ECN/PCN No.: M1303

For Manufacturer			
Product Description: Axial Power Inductor	Abracon Part Number / Part Series: AIAP-03	<input type="checkbox"/> Documentation only <input checked="" type="checkbox"/> ECN <input type="checkbox"/> EOL	<input checked="" type="checkbox"/> Series <input type="checkbox"/> Part Number
Affected Revision: <p style="text-align: center;">G</p>	New Revision: <p style="text-align: center;">H</p>	Application: <input type="checkbox"/> Safety <input checked="" type="checkbox"/> Non-Safety

Prior to Change:

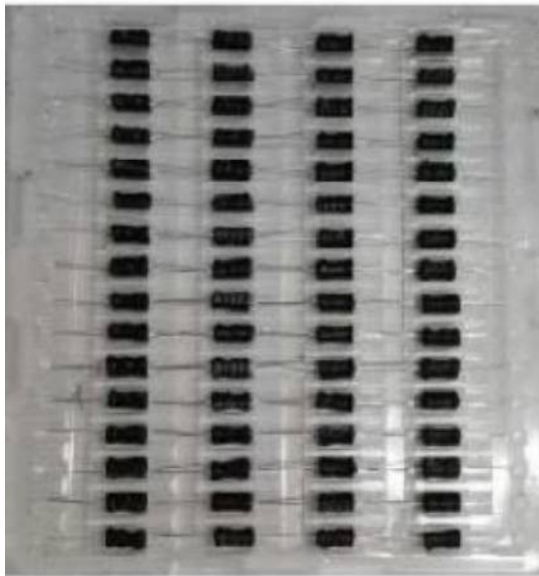
Cause/Reason for Change: Update to the packaging information to 64pcs/plat, Introduced the following PNs to the series 183K, 223K, 273K, 333K, 393K, 473K, 563K, 683K, 823K, 104K, 124K

3.0 Packing (64pcs/Plate)
